# SAFETY RELATED RECALL

Global Recall Action  
Number: **D113v1**

<b>Subject:</b>  <b>Defender 110 Third Row Seatbelt Mounting Bracket - Incorrect Specification</b>	<b>Publication No.:</b> D113v1
	<b>Model:</b> Defender (LE)
	<b>Model Year:</b> 2026
	<b>Date of Issue:</b> 13 April 2026

# SERVICE INSTRUCTION - D113V1

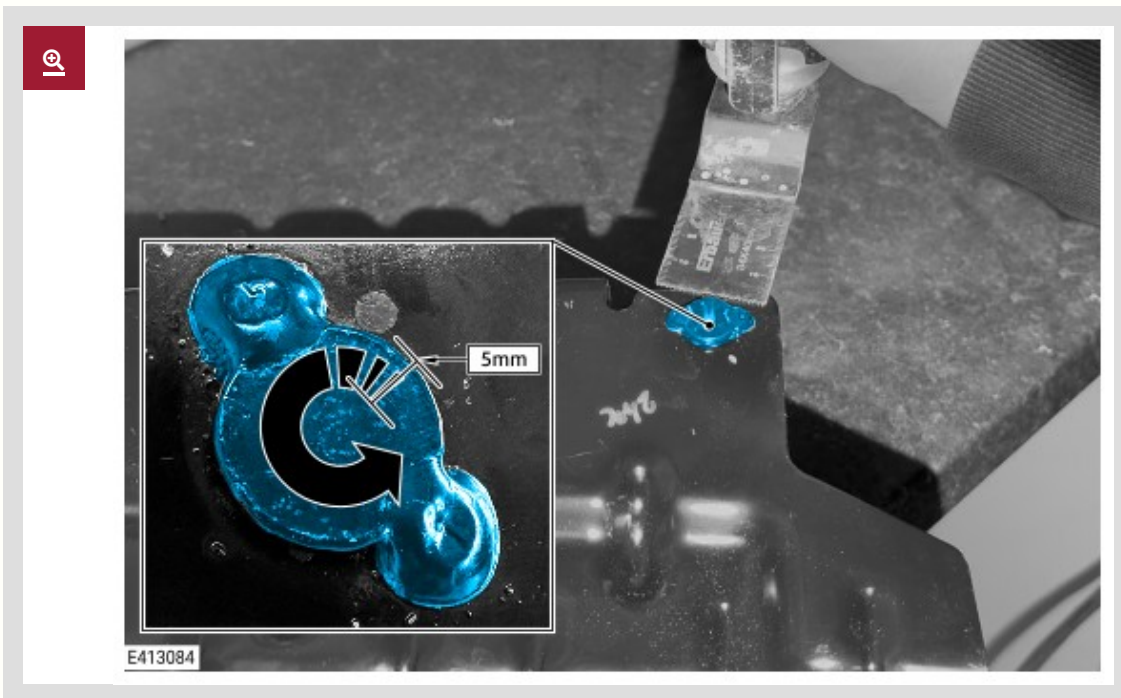
- Cut through the 2 welds securing the stud to the third row seatbelt anchor bracket.
- Cut a minimum of a 5 mm deep groove below the stud head and around the entire circumference of the stud.

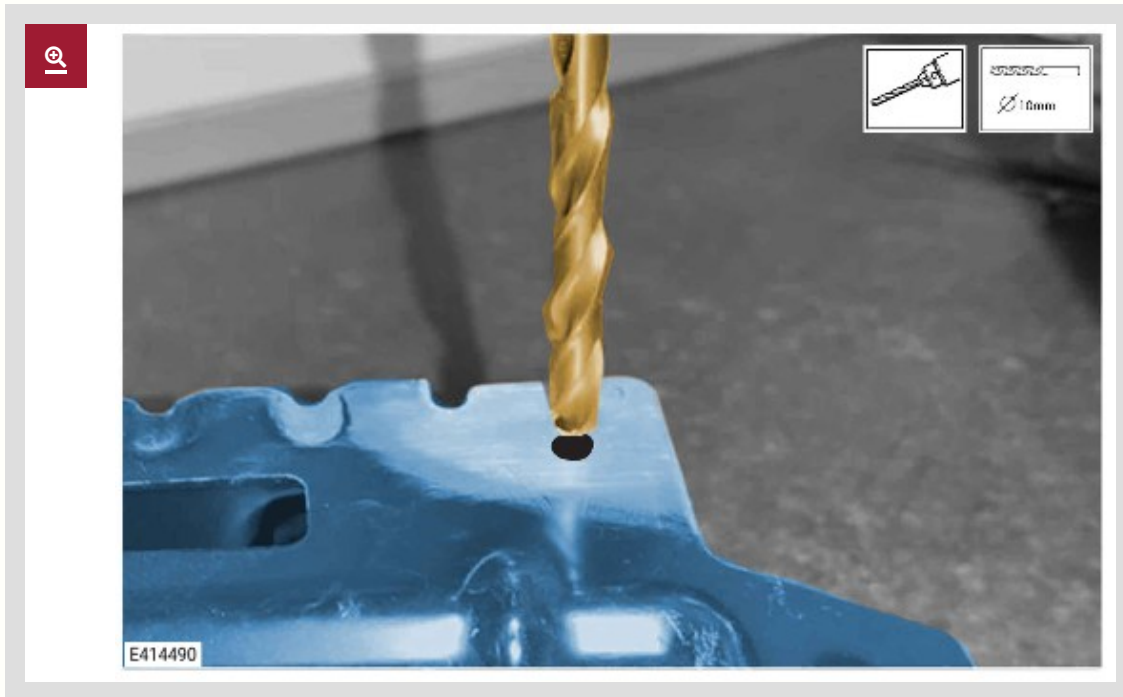
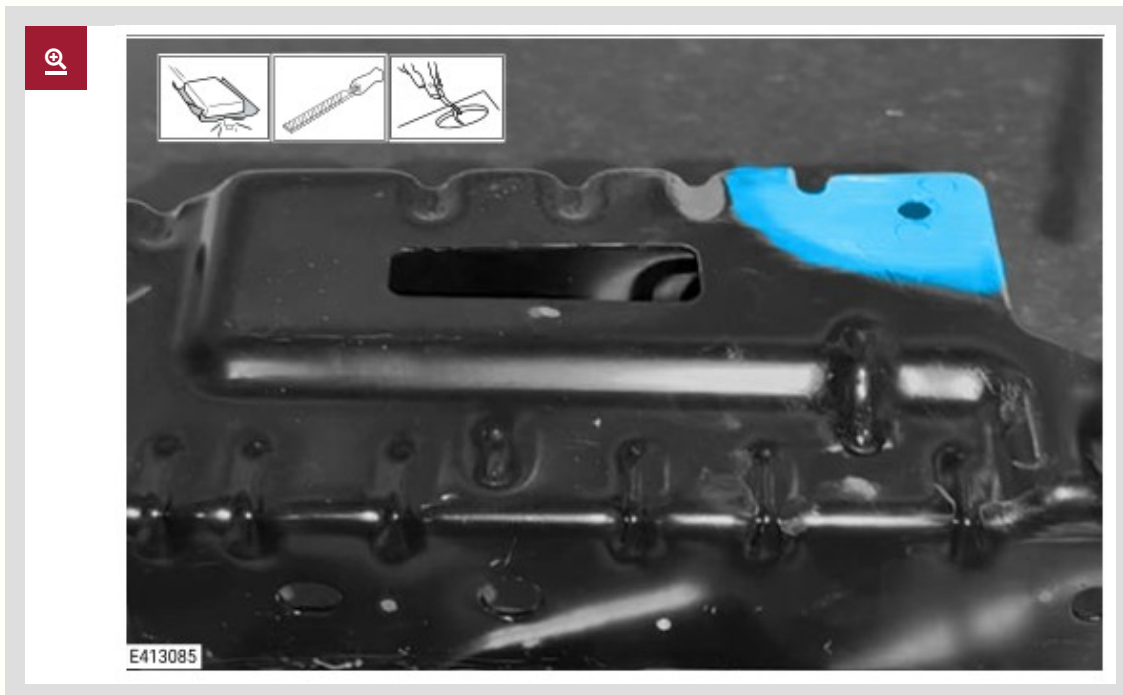
<b>To:</b>	All National Sales Companies (NSCs), importers, retailers and authorized repairers.
<b>For the Attention of:</b>	The approved JLR retailer / authorized repairer.
<b>Important:</b>	<p>Rest of World: Quarantine in JLR retailer / authorized repairer or applicable NSC location.</p> <p>NOTE: The information in this campaign is intended for use by professional technicians. If you are not a JLR retailer / authorized repairer, do not assume that a condition described affects a specific vehicle. Contact an authorized JLR retailer / authorized repairer to determine if this campaign applies to a specific vehicle.</p> <p>This bulletin supersedes Update Prior to Sale (UPS) UPS0926 with immediate effect. The blue highlighted text relates only to the date information. All text in this bulletin should be read and understood in full.</p> <p><b>The D113 Safety Recall has been updated to highlight the requirement for photographic evidence to be attached to the warranty claim. Drill out requirement is now 10 mm. Check and adhere to the new repair instructions.</b></p>

Run a 10 mm drill bit through the third row seatbelt anchor bracket hole.

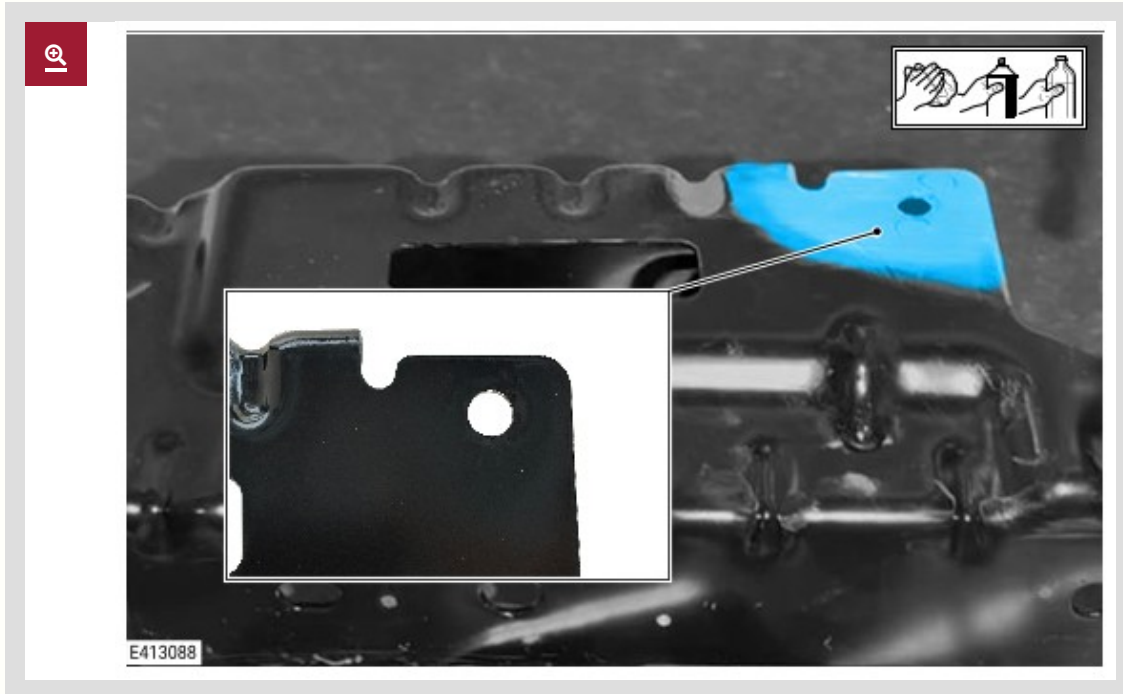
Complete the following 4 steps, the modified third row seatbelt anchor bracket **MUST** meet the requirements. **Take a photograph to show each of the below measurements being completed, including a photograph of the area to be inspected in step 3. The photographs must be attached to the Warranty Claim. Failure to follow this instruction may result in a rejection or delay in the claim being processed.**

1. Using the images provided for reference, measure the thickness of the third row seatbelt anchor bracket. There must be a **minimum** thickness of 2.2 mm within the 21 mm perimeter around the drilled hole. Also, specifically measure the thickness of the areas marked A, B, and C. The deviation in thickness across points A, B, and C **MUST NOT** exceed 0.5 mm.

2. Measure from the edge of the drilled hole to the edge of the third row seatbelt anchor bracket, in the areas shown.
  - D) There **MUST** be a **minimum** of 7.8 mm from the edge of the drilled hole to the edge of the third row seatbelt anchor bracket, in the area shown.

- E) There **MUST** be a **minimum** of 12.5 mm from the edge of the drilled hole to the edge of the third row seatbelt anchor bracket, in the area shown.

3. Visually inspect the wider area of the third row seatbelt anchor bracket shown as Dark Blue in the illustration and marked F. Inspect for any incidental damage caused during steps 9 to 12. Any incidental damage present **MUST NOT** reduce the thickness of the third row seatbelt anchor bracket to less than 2.2 mm in the area shown.

4. Measure the diameter of the drilled hole. The diameter of the drilled hole **MUST** measure between 10 mm - 10.5 mm.
